NO: 23-14-99

SUBJECT: Door Weather Seal Retention

This bulletin involves installing foam tape on door seal flange to assure proper sealing and retention.

FIGURE 1

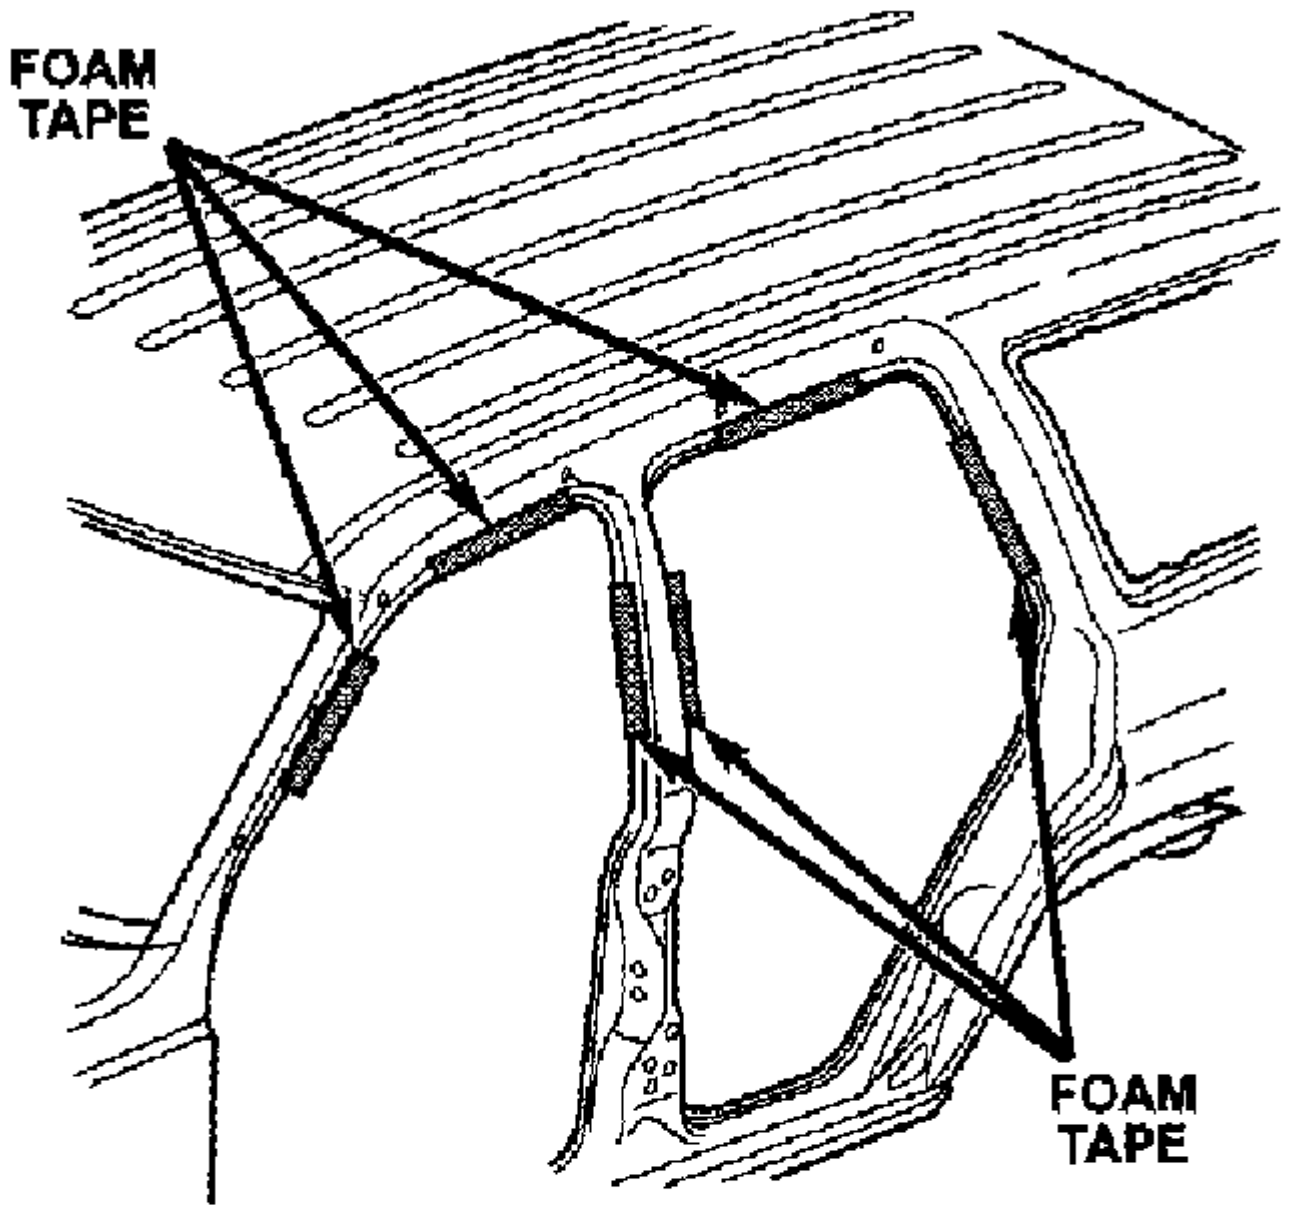
The door weather seals may not fit the door flange properly. This can cause loose or sagging door seals and the associated wind and water leaks.

Inspect the door weather seals. If the seals are loose or sagging and do not fit tightly on the flange, perform the Repair Procedure.

1. Open the door and pull the door seal down away from the flange.
2. Apply three 12-inch strips of foam tape, p/n 04318028, to the flange in the areas shown (see [Figure 1](#)) for each affected door.
3. Install the seal making sure that the seal is fully seated on the flange.
